Access Compliance Report Public Rights-of-Way (Curb Ramps)

Intersection ID: 15869 Main Street: MARSH RD **Cross Street: SEDGEFIELD RD** Location: ADA ID: 5F4FC38452C0 Ramp Type: PerpDiag Initial Pass/Fail: Fail **Overall Compliance: No** Severity Score: 13.75

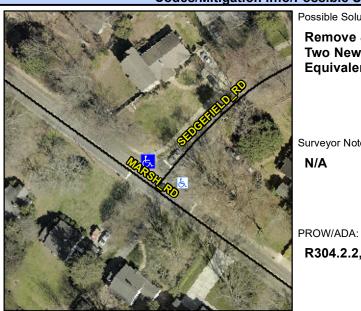
R304.2.2, R304.5.3

Compliance Description		Data	Compliance		Description	Data
N/A	Ramp Length (in)	64.0	No	Ramp	Slope (%)	8.4
Yes	Ramp Width (in)	48.0	No	Ramp	XSlope (%)	2.8
N/A	Flare Type LT	N/A	N/A	Flare	Type RT	N/A
N/A	Flare Slope LT (%)	N/A	N/A	Flare	Slope RT (%)	N/A
N/A	Flare Traversable LT?	N/A	N/A	Flare	Traversable RT?	N/A
N/A	Landing Length (in)	N/A	N/A	DWS	Provided?	N/A
N/A	Landing Width (in)	N/A	N/A	DWS	Contrast?	N/A
N/A	Landing Slope (%)	N/A	N/A	DWS	Length (in)	N/A
N/A	Landing X Slope (%)	N/A	N/A	DWS	Full Width?	N/A
N/A	Landing Curb? (Y/N)	N/A	N/A	DWS	Offset (in)	N/A
N/A	Shared Landing?	N/A				
N/A	Gutter Ponding?	N/A	N/A	Gutte	r Slope (%)	N/A
N/A	Gutter Lip Ht (in)	N/A	N/A	Gutte	er X Slope (%)	N/A
N/A	Painted X Walk1?	No	N/A	Paint	ed X Walk2?	No
	X Walk 1 Direction	To SW		X Wa	lk 2 Direction	To SE
N/A	X Walk 1 Width (in)	N/A	N/A	X Wa	lk 2 Width (in)	N/A
	X Walk 1 Slope (%)	2.0		X Wa	lk 2 Slope (%)	2.6
	X Walk 1 X Slope (%)	0.4		X Wa	lk 2 X Slope (%)	0.8

MARSH RD StopSign Possible Solutions: **Remove & Replace Curb Ramp With** Two New Directional Ramps or Equivalent.
